## Attachment A

### Technical Specification Change to APRM Setpoints

Reference is made to Pilgrim Station Operating License No. DPR-35 Appendix A. The bases for Specifications 2.1.A.1 and 2.1.B contain information pertaining to the APRM High Flux Scram (Run Mode) trip setting and the APRM Rod Block (Run Mode) trip setting as follows:

Pursuant to 10 CFR 50.59 Boston Edison hereby proposes the following changes to Appendix A of License No. DPR-35.

FIGURE 8.2.2  
 PILGRIM 1 STATION ORGANIZATION

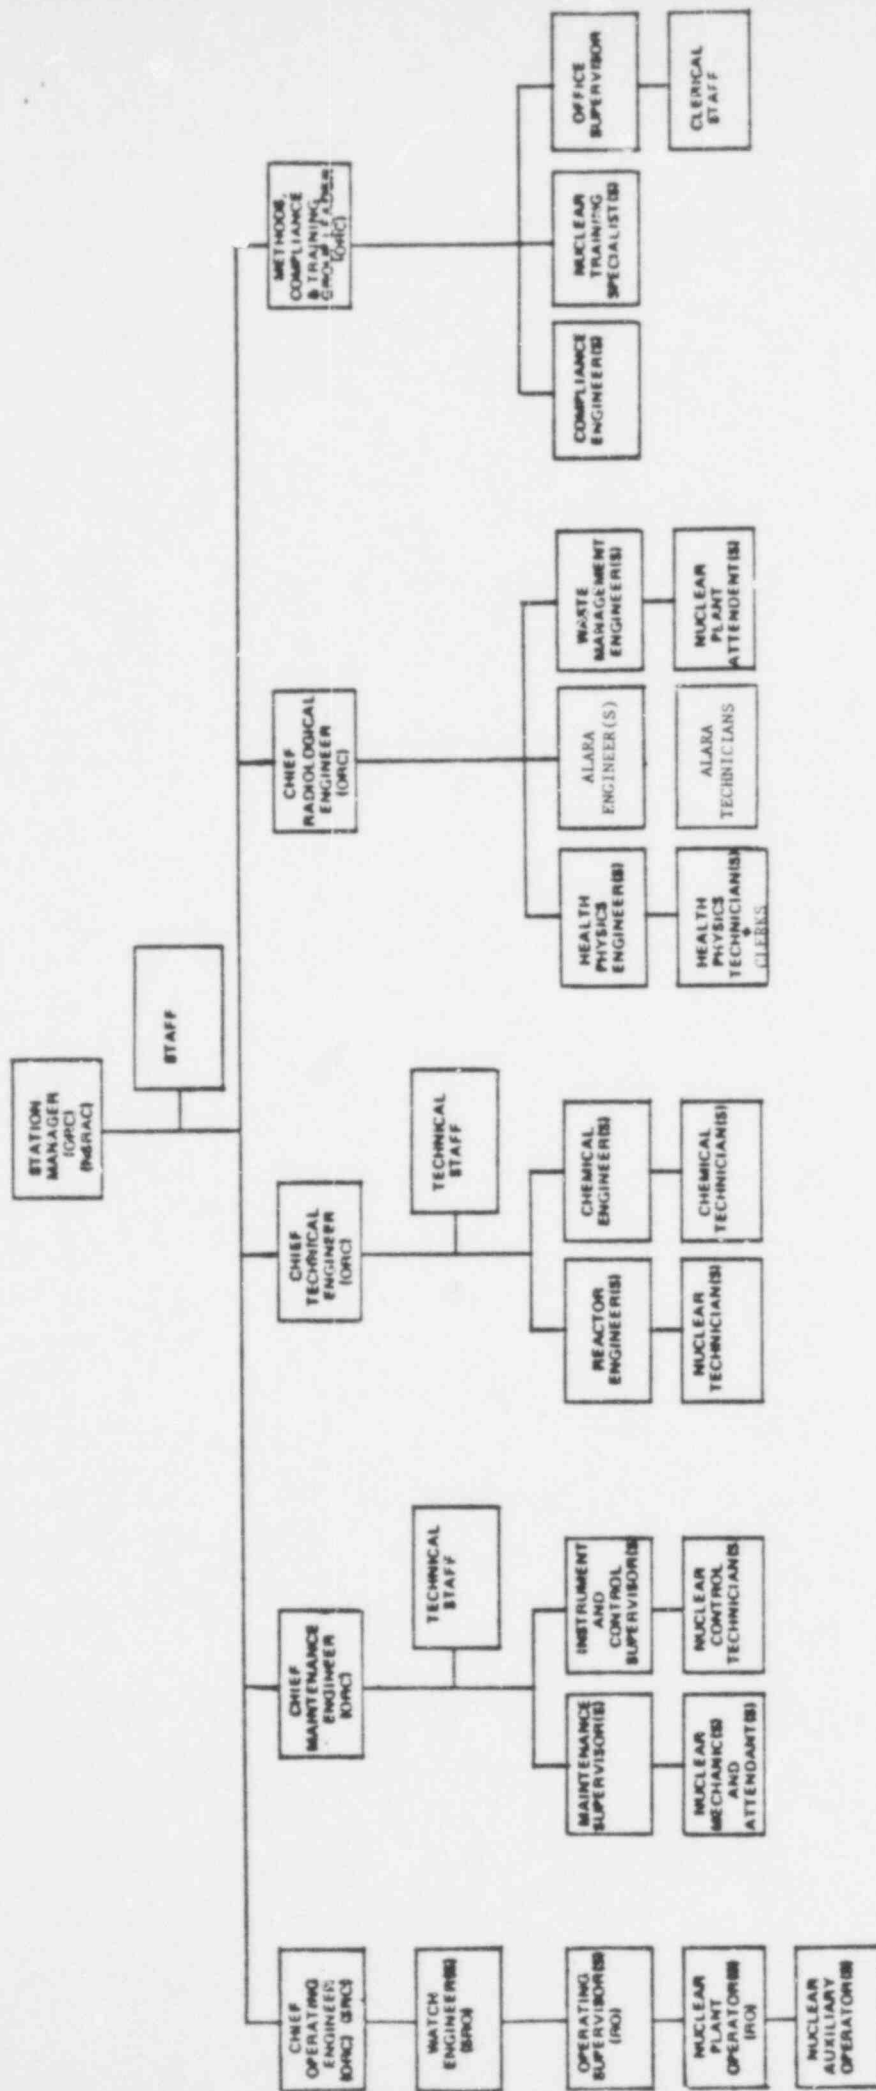
Reference is made to Pilgrim Nuclear Power Station - Unit #1 Technical Specification Appendix A, Section 6, Figure 6.2.2, titled "Pilgrim #1 Station Organization". The changes would consist of restructuring the chart (Exhibit A) to accommodate organizational changes at the Station. Also, Section 6.5.A.2 "ORC Composition" will be updated to reflect another ORC member.

Recently, Boston Edison Company has initiated changes to improve the Health Physics Program at Pilgrim and as a result new positions have been created. The subject positions are titled as follows:

Prior to the creation of the Chief Radiological Engineer the Health Physics Program was under the responsibility of the Chief Technical Engineer. It is Boston Edison's intention, by means of these new positions, to increase Station management's attention toward the Health Physics Program.
